**Government of India
Ministry of Railways
Research, Designs & Standards Organisation
Manak Nagar, Lucknow - 226 011**

MODIFICATION SHEET NO. RDSO/WAM4/81

**MODIFICATIONS TO BASE PLATE FIXING ARRANGEMENT AND
TERMINAL CONNECTION SCREWS FOR VANE TYPE AIR FLOW
RELAY OF M/S ROTOMAC.**

MODIFIED FIXING ARRGT. FOR BASE PLATE
OF ROTOMAC AIR FLOW RELAY

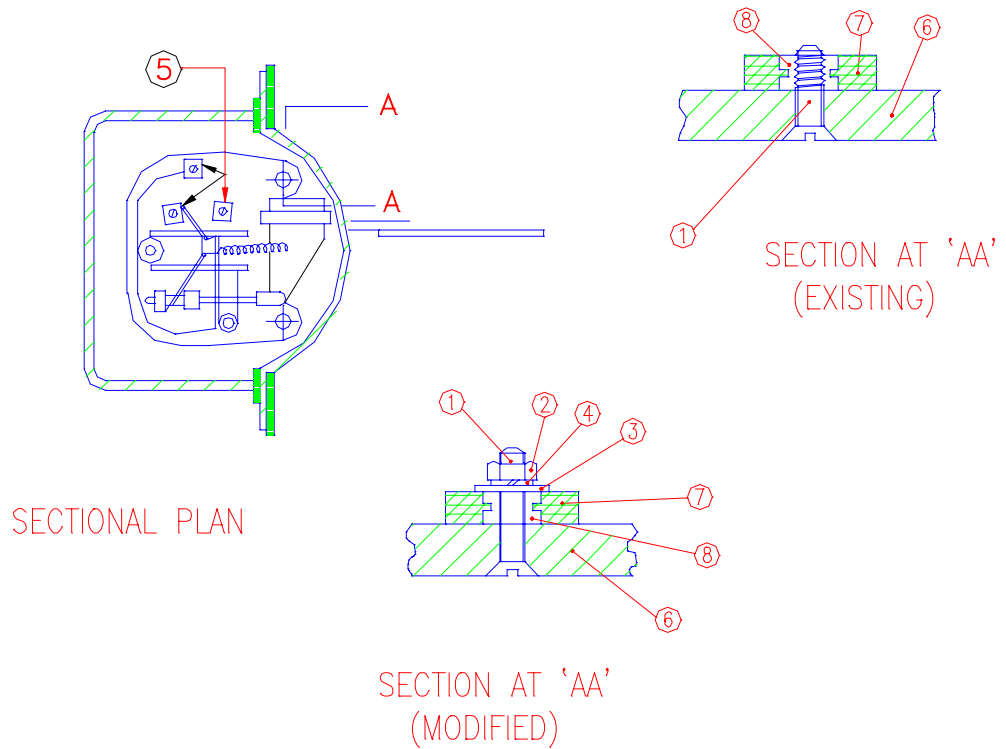
- 1.1** Sheds have reported cracking and breakage of bakelite base plate at the brass insert location. This probably occurs when tightening the terminal connections. M/s. Rotomac have agreed to change over to a stronger grade of bakelite conforming to grade 4 of IS: 1300 for the base plate in future supplies.
- 1.2** Sheds may ensure that replacements of these base plate are also in bakelit of grade 4 of IS:1300 without metal inserts.
- 1.3** In order to minimise failures in existing relay the following modifications may be made to reduce the stresses on the bakelite baseplate.

- 2.1** Remove the relay from the loco and dismantle the relay carefully. Remove the threads of the both metal inserts in the base plate by drilling carefully at high speed with 5.2 mm drill (see drg. No. SK EL 3109).
- 2.2** Check that the surfaces on which the base plate is supported are smooth and in level plane. If not, they should be dressed with a fine file.
- 2.3** Replace the base plate in position using M5x20 CSK screws, plain washers, spring washers and nuts as shown in SK EL 3109. Tighten the screws on both sides alternately by hoding the nut and avoiding excessive strain on the base plate.
- 2.4** Apply drops of araldite on the screw head and on the nuts.
- 2.5** Remove the existing 3 nos. choose head terminal screws and substitute by hexagonal head screws without slot, m4x10-3 nos.

2.6 Assemble the relay, clean the components and test for proper function.

8.	METAL INSERT	—	2	BRASS	—	EXISTING MODIFIED
7.	BASE PLATE	—	1	BAKELITE GR.4, IS :1300	—	EXISTING
6.	RELAY BODY	—	—	ALUMINIUM	—	EXISTING
5.	SCREW, HEX. HEAD W/O SLOT	M4x10	3	STEEL IS : 2389	CD. PLATING BS : 3382-PT.1	REQUIRED
4.	FAN DISC WASHER-A	M5	2	STEEL IS : 5556	CD. 8 IS : 1572	REQUIRED
3.	PLAIN WASHER (OD = 3X ID)	M5	2	STEEL IS : 5370	CD. 8 IS : 1572	REQUIRED
2.	NUTS	M5	2	STEEL IS : 2389	CD. PLATING BS : 3382-PT.1	REQUIRED
1.	CSK SCREW	M5x20	2	STEEL IS : 1365	CD. PLATING BS : 3382-PT.1	REQUIRED
PART NO.	DESCRIPTION	SIZE	QTY.	MATERIAL & SPECIFICATION	FINISH & SPECIFICATION	REMARKS
